INSTALLATION INSTRUCTIONS FOR CODE #1
MODIFICATION KIT #9010-14-00001 TO HXL-1
LINEAR AMPLIFIER

SCHEMATIC DIAGRAM
LINEAR AMPLIFIER (HXL-ONE)

**Installation Instructions for Code #2
Modification Kit #9010-14-00002
to HXL-1 Linear Amplifier**

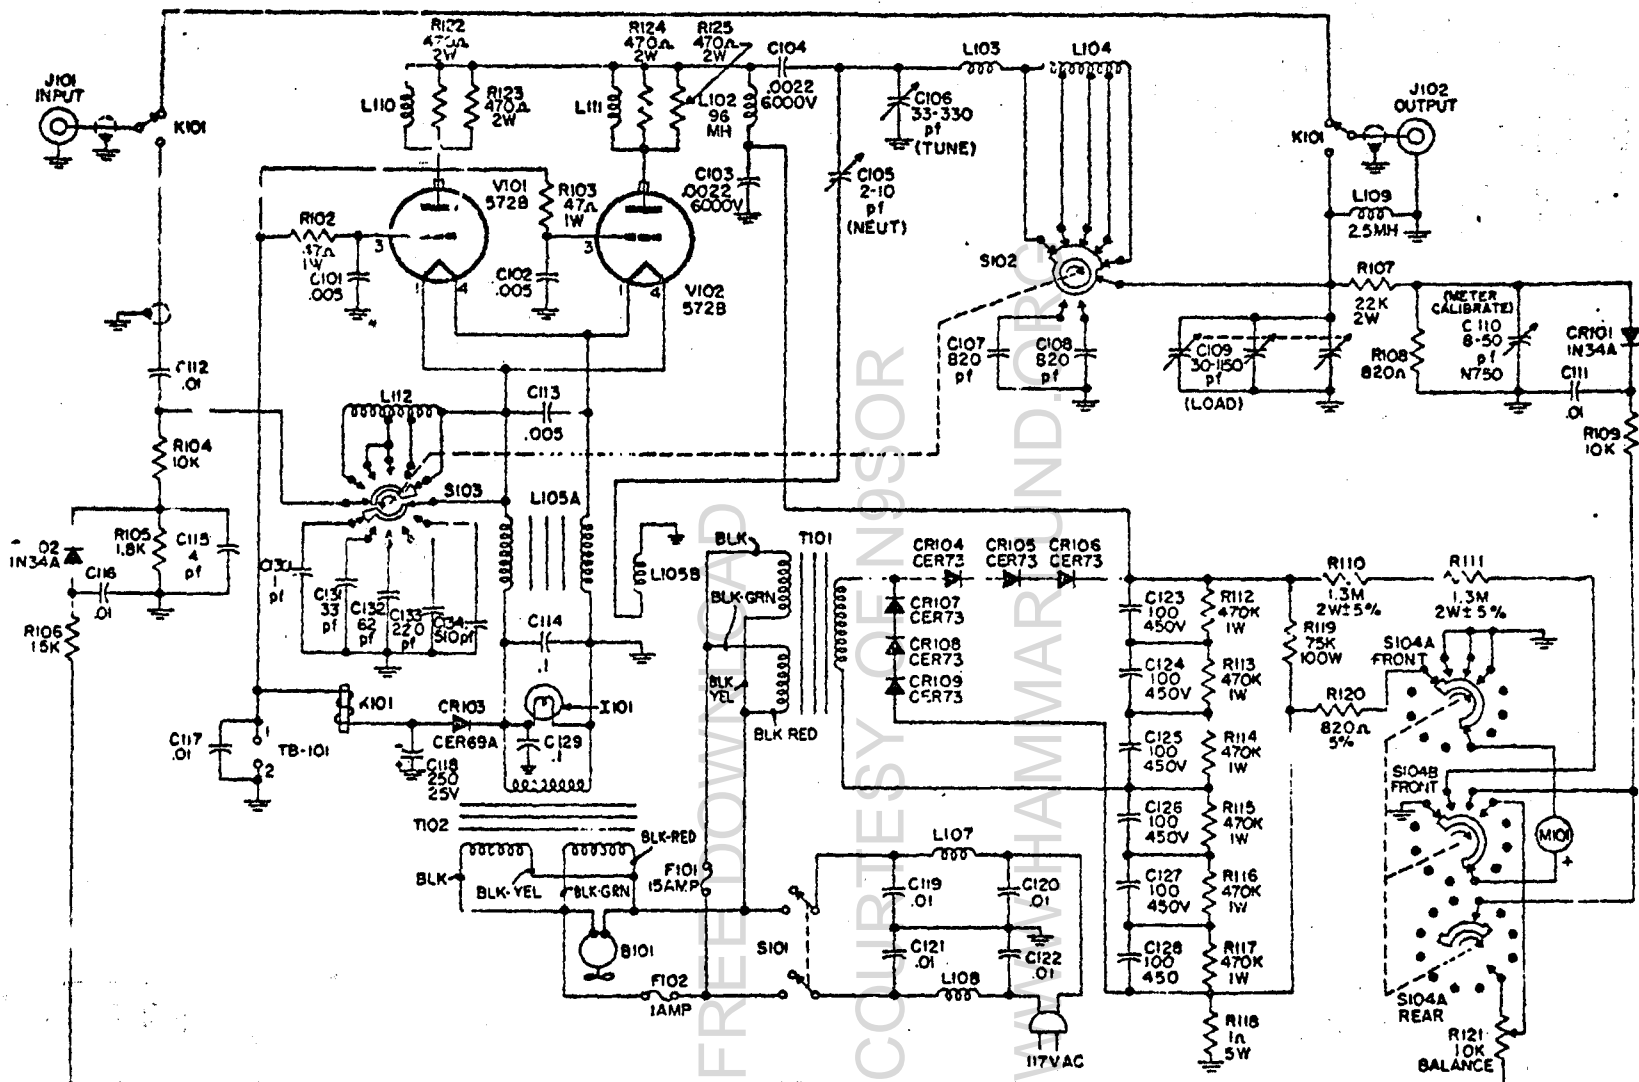
Disregard Schematic Diagram in present manual, use new Schematic Diagram attached to these instructions.

BOTTOM VIEW OF TUBE TRAY AFTER CODE 2 MODIFICATION

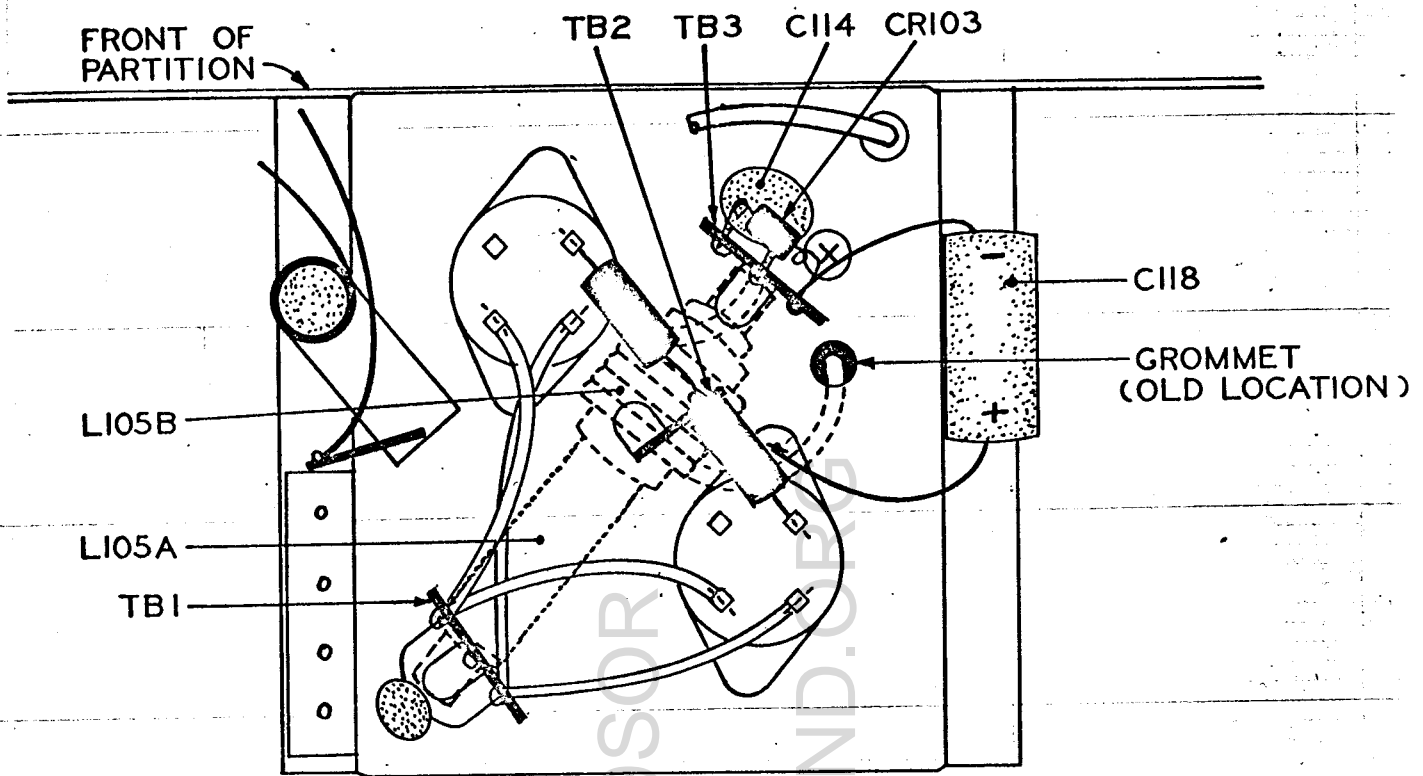
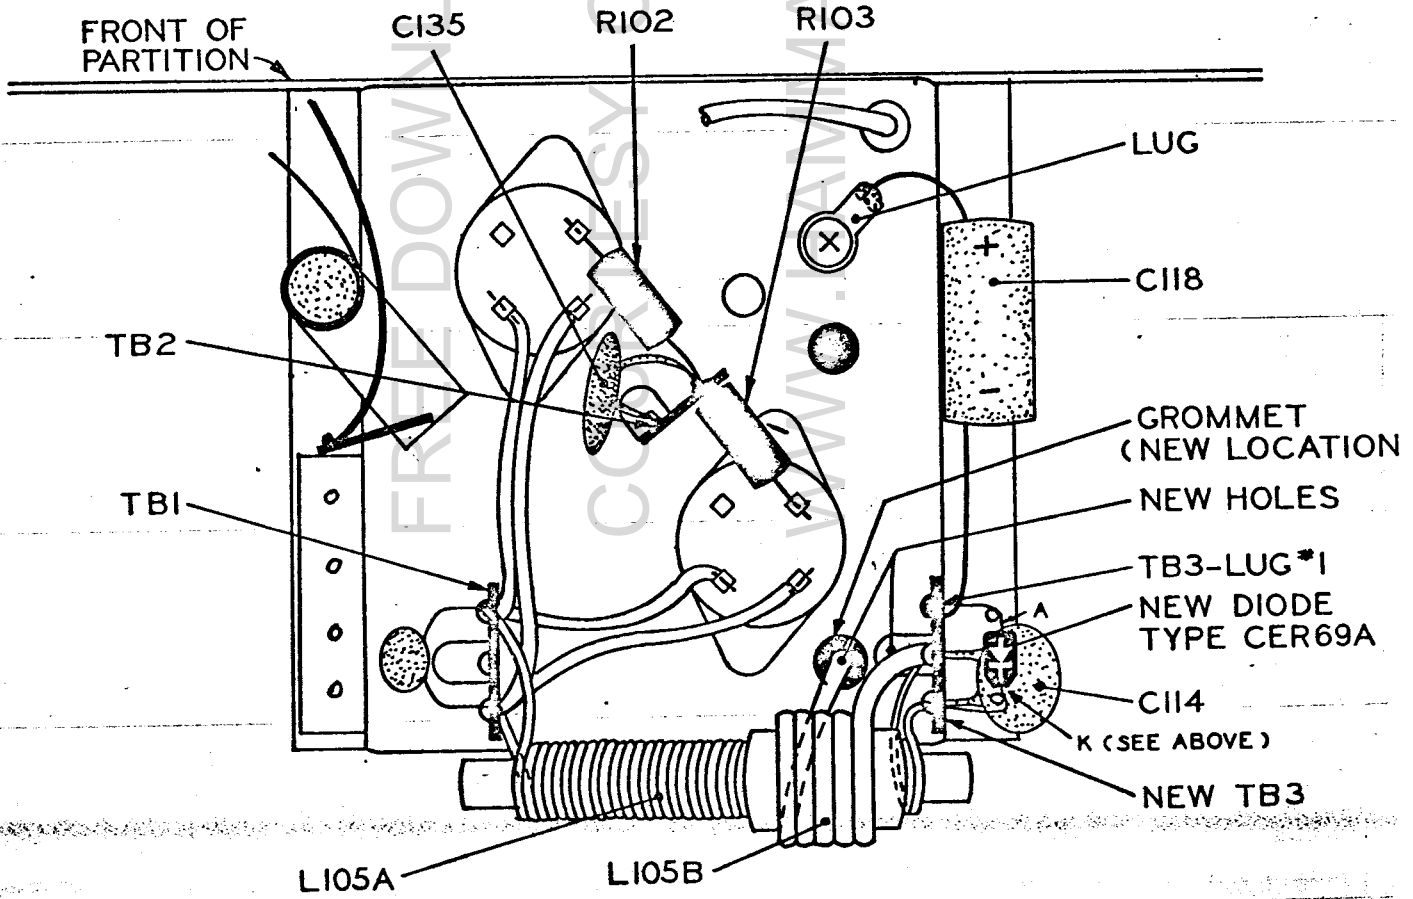
1. Unsolder and remove as a unit, L105A and L105B (Bifilar Coil Assembly).
2. Remove filament wiring (4 brown wires from TB1 to Tube Sockets) and discard.
3. Soften solder on terminal strip TB1 rivet and rotate terminal strip 45° clockwise until parallel with edge of tube tray, as per illustration.
4. Disconnect and remove C118, (250uf capacitor) turn 180° and remount; do not connect at this time.

15. Replace red filament transformer leads to the new terminal strip TB3, lugs 2 and 3. Keep the wires close together and close to the chassis.
16. Mount a new diode (Part #4804-02-00002) Type CER69A between lugs 1 and 3 of TB3. (Cathode end on lug 3, see bottom view, Page 4.)
17. Mount the new .1uf @100V disc capacitor (C114) to the new terminal strip TB3 between lugs 2 and 3.
18. Connect the C118 negative lead to the terminal strip TB3, lug 1.
19. Connect the brown lead from step #6 to the new terminal strip, lug 3.

20. Connect white/black lead to the new terminal strip, TB3, lug 1, shorten wire to fit.
21. Connect white/blue lead to the junction of R102 and R103 on TB2. Shorten wire to fit.
22. Add a .01uf (Part #1509-01-01011) C135 disc capacitor to the same point as white/blue lead on TB2 and other end to ground; solder connections.
23. Add new filament wires between the tube sockets and the terminal strip (TB1) which was rotated in step 3. Keep the wires to each tube close together and close to the chassis. Solder at tube sockets.
24. Mount bifilar coil assembly (L105A) to the terminal strips. Connections to TB1 are as before. Connections to TB3 are as follows:
 - a. 2 bare leads from L105A to lugs 2 and 3 of TB3.
 - b. Covered heavy insulated lead from L105B to lug 2 on TB3.

Figure shows bifilar coil assembly (L105A & L105B) off to side of tube tray for better clarity of wiring. Assembly is to be mounted directly over terminal strips TB1 and TB3. This is necessary to insure proper operation.

BOTTOM VIEW OF TUBE TRAY SHOWING FIELD DRILLED HOLES
CODE 2 MODIFICATION - STEP 12

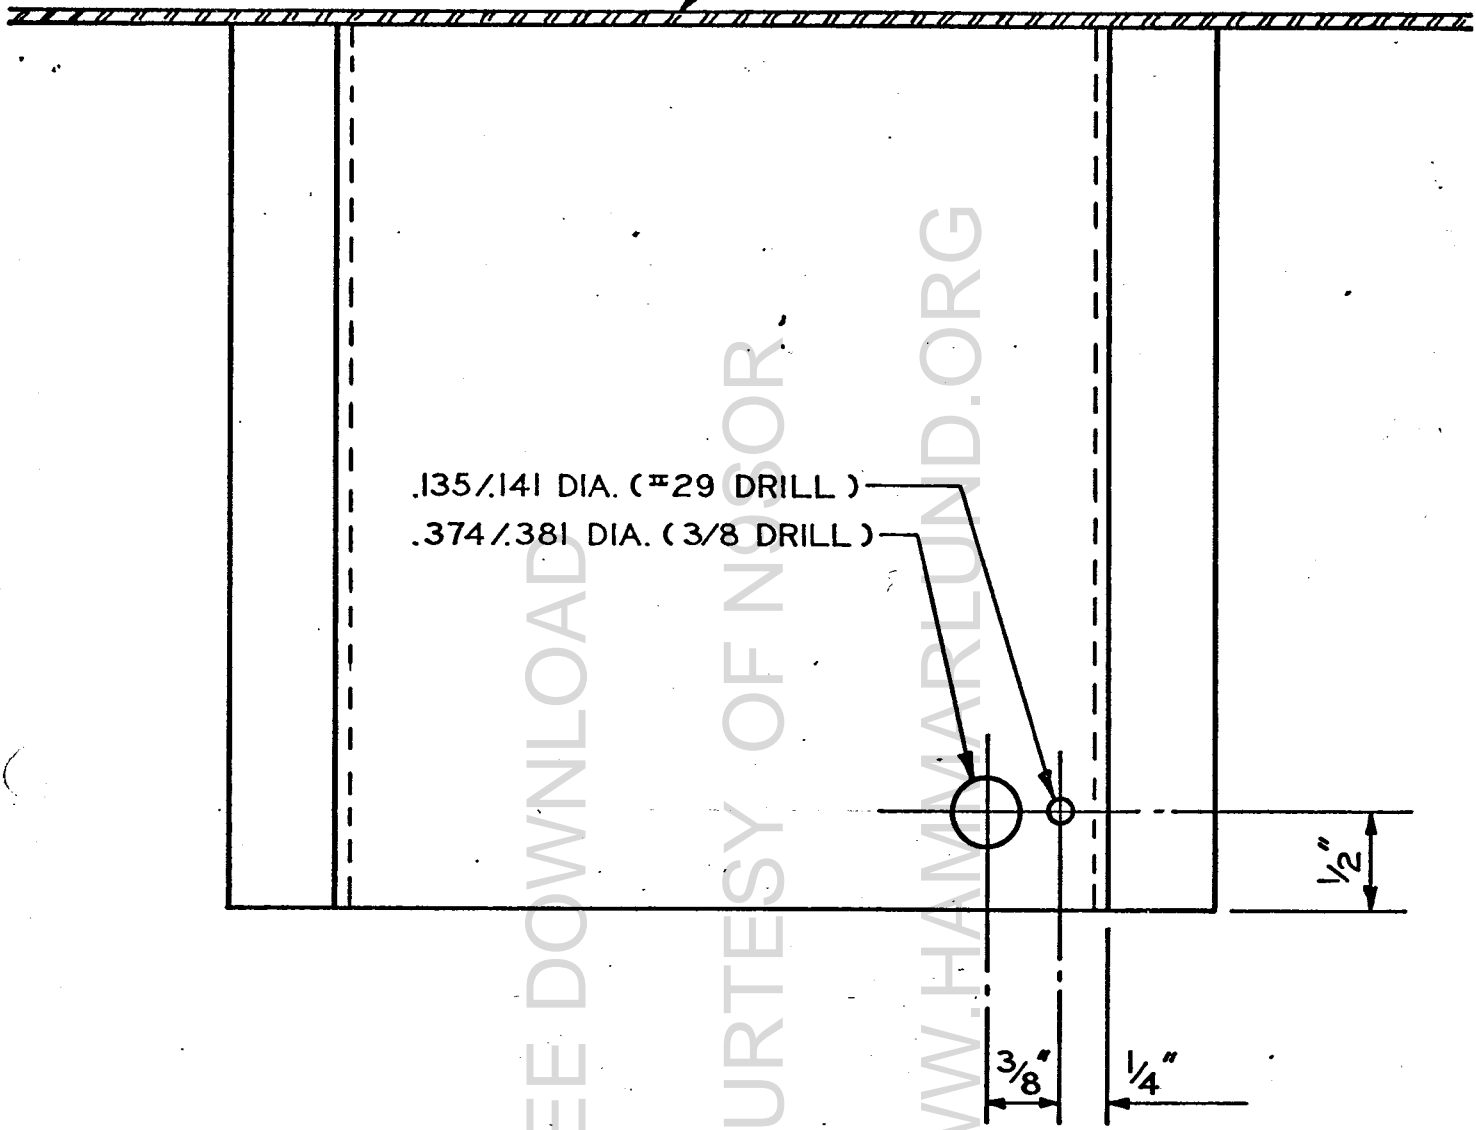
12. Drill (2) holes in tube tray per attached drawing.
13. Mount new terminal strip (Part #2885-01-00012) in the small hole using screw and Keps nut and spot solder to tube chassis. This replaces the old terminal strip TB3.

14. Remove grommet from top center hole and place in the new hole.
